**Defence
Infrastructure
Organisation**

SAFETY ALERT

Subject: Schneider Electric Vigi Earth-Leakage Protection Modules & Insulation Monitoring Modules – Product Safety Notice

Number: SA 16/11

A/ Vigi Earth Leakage protection module (VIGI) :

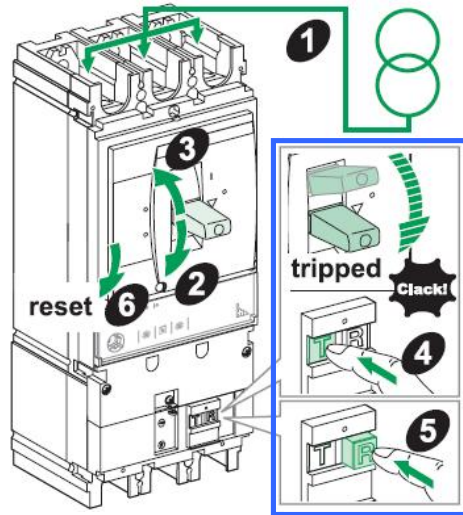
- 1Power supplied
- 2, 3.....Circuit Breaker ON,
- 4Push T button on Vigi : Circuit Breaker must trip
- 5Push R button on Vigi: Vigi rearmed
- 6Reset Circuit Breaker

Perform three times operations 2 to 6

B/ Insulation Monitoring module :

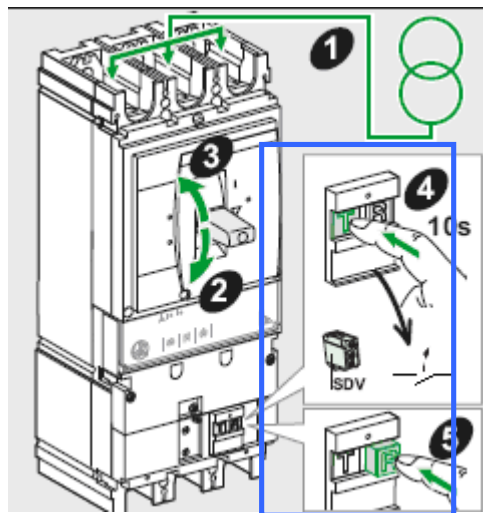
- 1Power supplied
- 2, 3.....Circuit Breaker ON,
- 4Push T button on Vigi: Red led lights, auxiliary contact must switch
- 5Push R button on Vigi: module rearmed

Perform three times operations 4 and 5
